**RE: Executive Summary for LD-25-01 – 1526 Fairview Avenue**  
**PARID: 30-00-18860-00-1/ TMID: 30196 017**  
**Preliminary/Final Major Subdivision & Land Development Plans Review (2<sup>nd</sup> Submission)**

**RE: LD-25-01 – 1526 Fairview Avenue**  
**PARID: 30-00-18860-00-1/ TMID: 30196 017**  
**Preliminary/Final Major Subdivision & Land Development Plans Review (2<sup>nd</sup> Submission)**

# LD-25-01 PRELIMINARY/FINAL MAJOR LAND DEVELOPMENT PLANS

OUTLET CONTROL STRUCTURE  
(NOT TO SCALE)

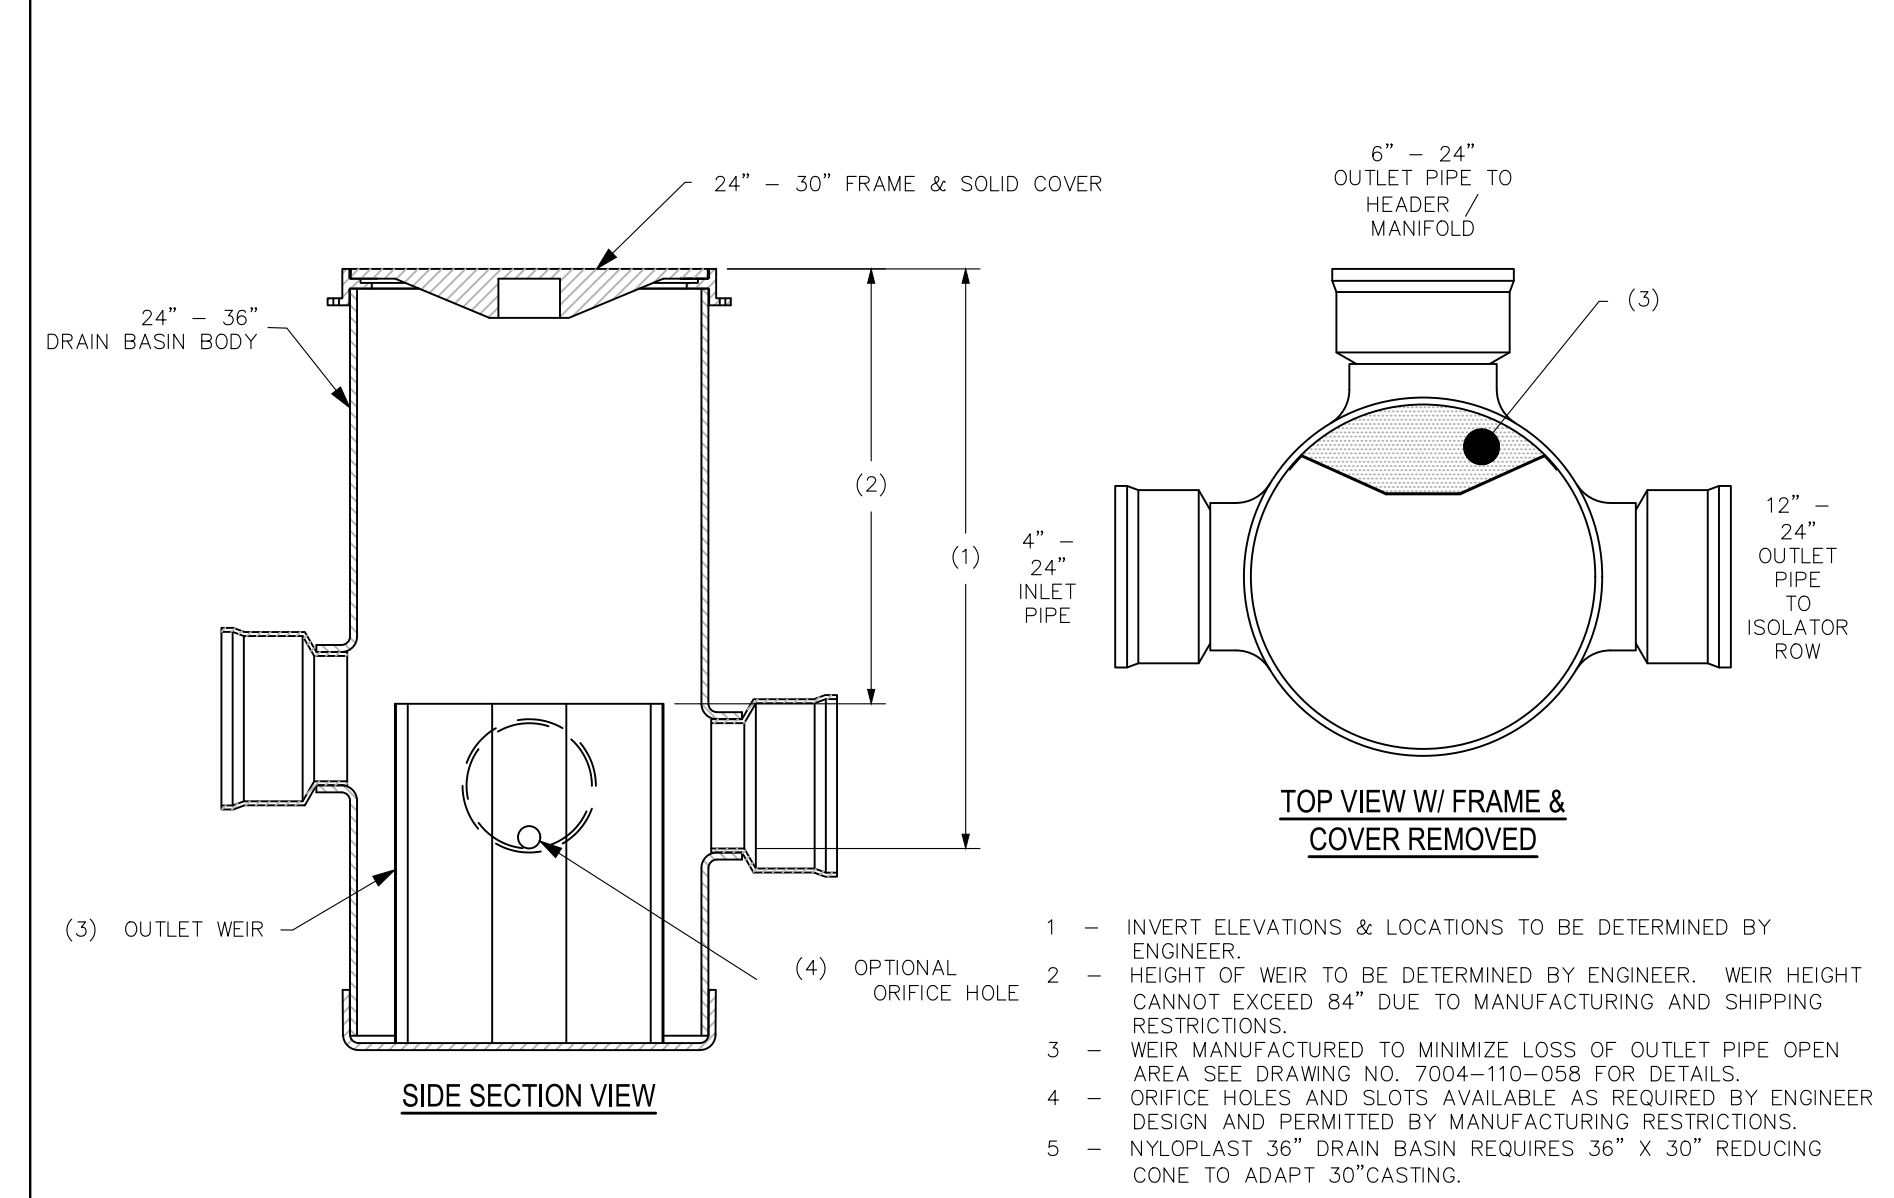
- o Add flow dissipator or rip-rap apron for the downspout discharge pipe into the raingarden.
  - o On the Outlet Control Structure Detail provided on the plans, the inlet pipe is labeled as 15"; however, on the plans, the inlet pipe is a 4" perforated pipe. The detail shall be revised accordingly.

1. The Applicant shall update the PCSM calculations to clarify the volumes for the evapotranspiration, non-structural design.
2. Add flow dissipator or rip rap for the downspout discharge pipe in the rain garden for E & S control.
3. On the "Outlet Control Structure Detail" provided on the plans, the inlet pipe is labeled as "15" Inlet Pipe"; however, on the plans, the inlet pipe is a 4" perforated pipe. This detail shall be revised

SANITARY DETAILS  
(NOT TO SCALE)

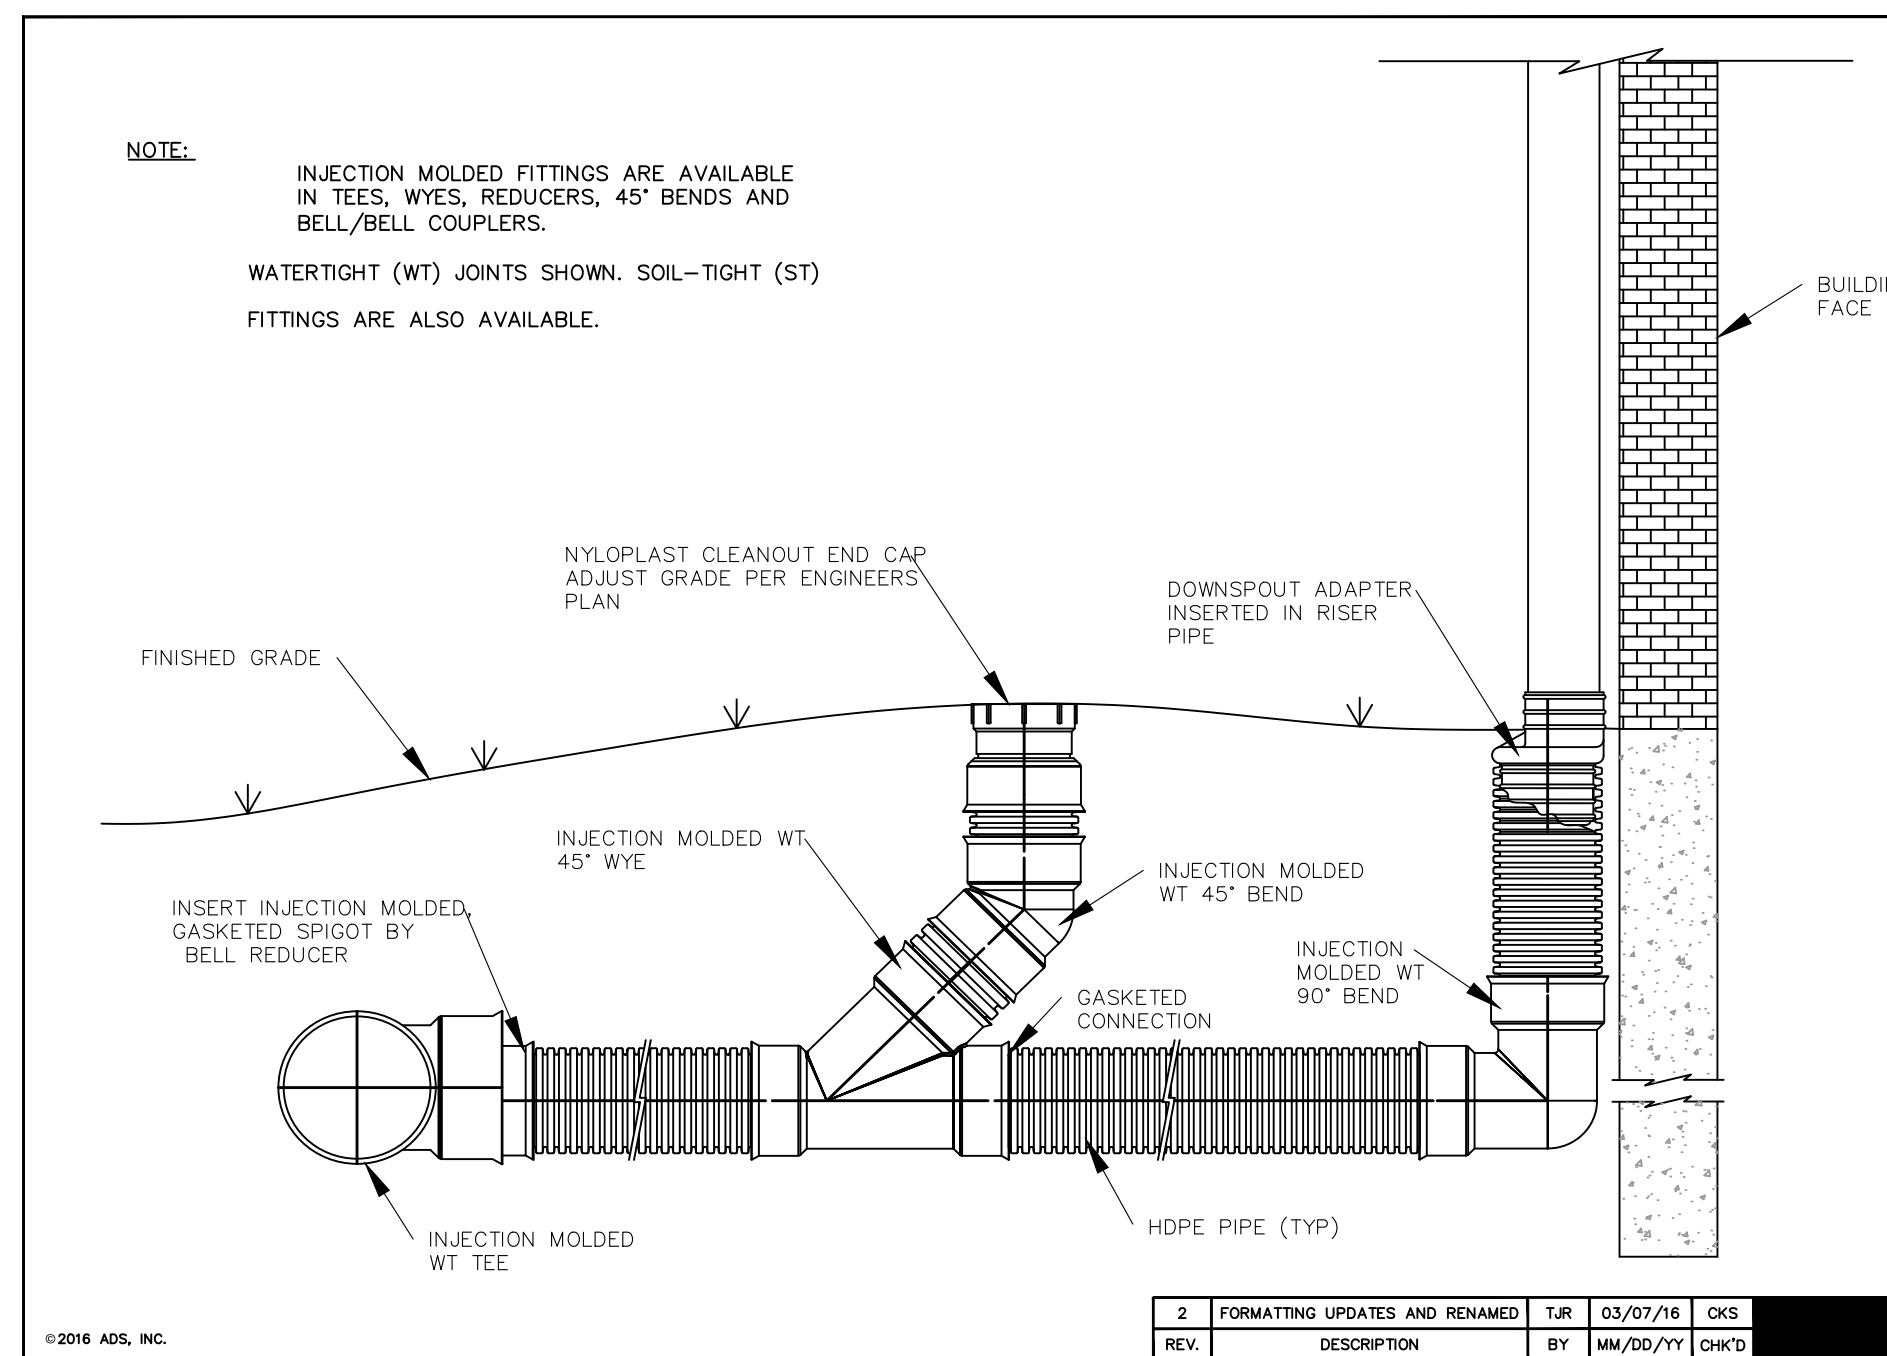
- Sanitary Sewer:
  - o Plan is indicating two cleanout fittings on the two 45 degree elbows. A cleanout should not be located at the same point into the sewer line as any other fitting. There is only the need for one cleanout fitting, which should be located in the grass area adjacent to the driveway apron.

- o The "Typical Cleanout Detail (Paved Areas)" and the "Typical Cleanout Detail (landscape Areas)" should be removed from the plans and replaced with the Township of Abington Typical Building Sewer Cleanout Assembly which utilizes a 2-way cleanout tee fitting. The proposed cleanout adjacent to the driveway apron should also be protected by a cleanout frame and cover assembly which should be added to the Construction Details Sheet. Also, the Township of Abington Trench Restoration Lawn/Wooded Areas should be added to the Construction Details Sheet.

## 1 H-7 INFILL DEVELOPMENT OPENINGS-TO-WALLS RATIO REQUIREMENT

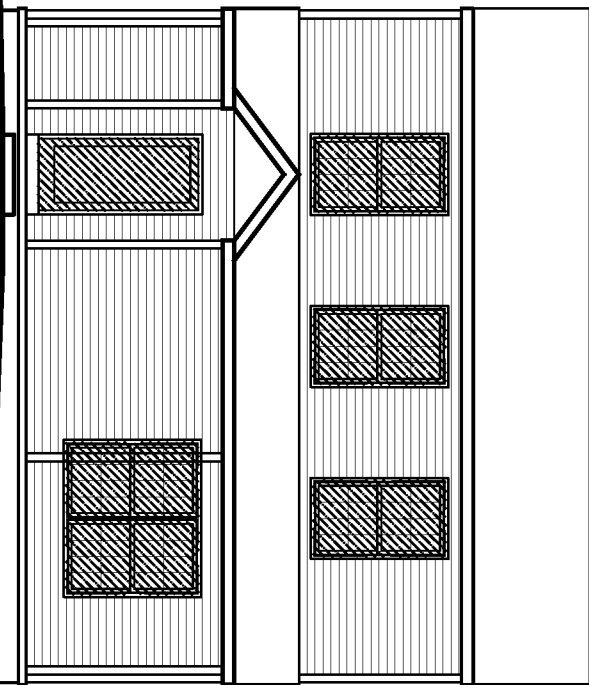
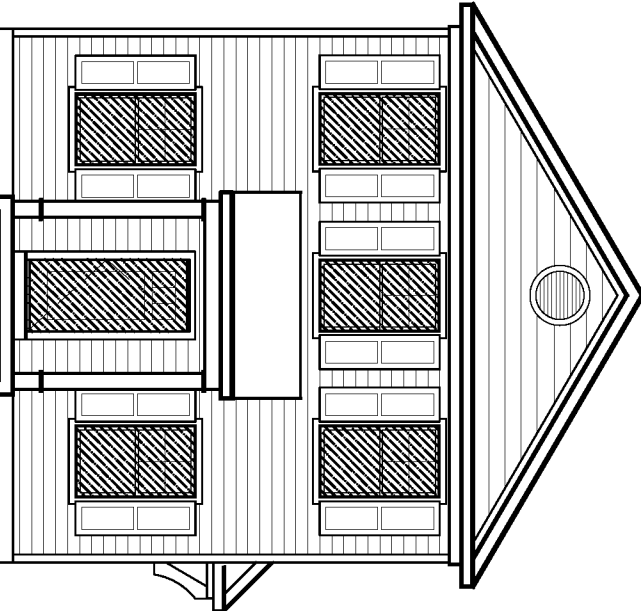
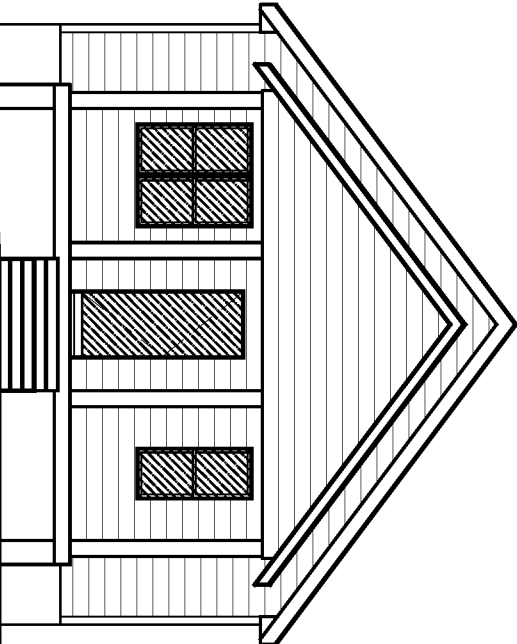
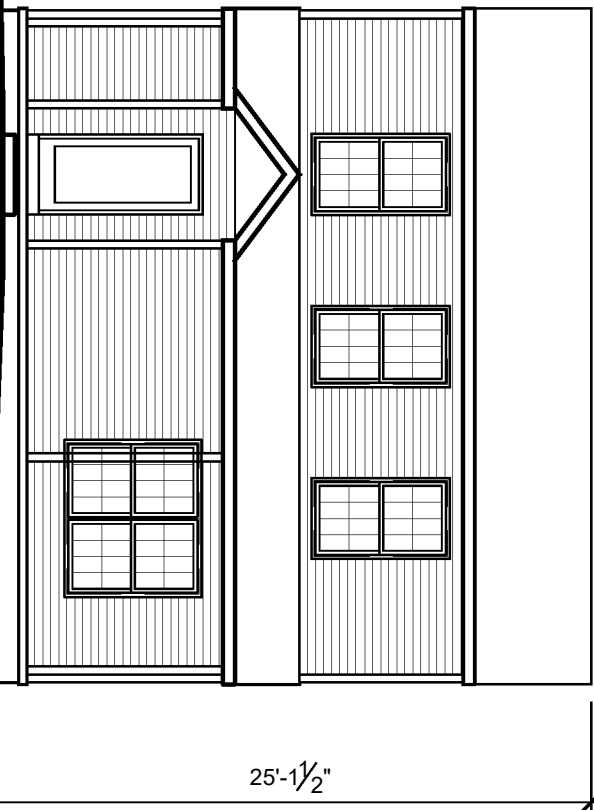
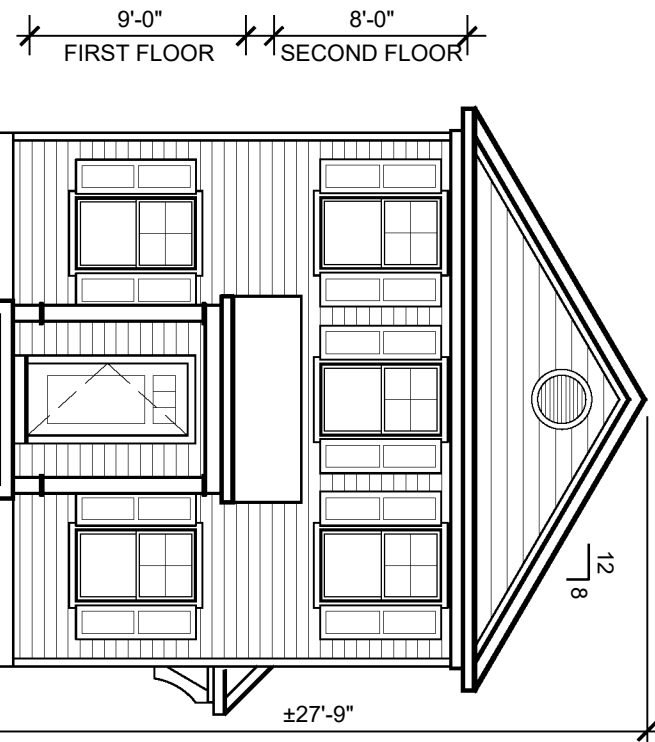
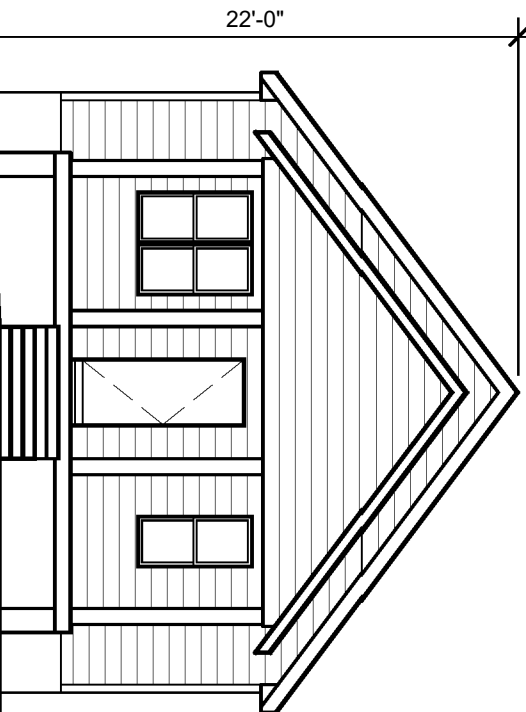
**Based on our measurements of the Architectural Plans provided, the height and length of the proposed dwellings will be approximately 24 feet high and 52 feet long, respectively, which complies with the building height and length requirements. The Applicant shall revise the Zoning Data Table on the Site Plan (Sheet 1) to show the actual proposed building height and length to clarify and ensure compliance with this Code Section.**
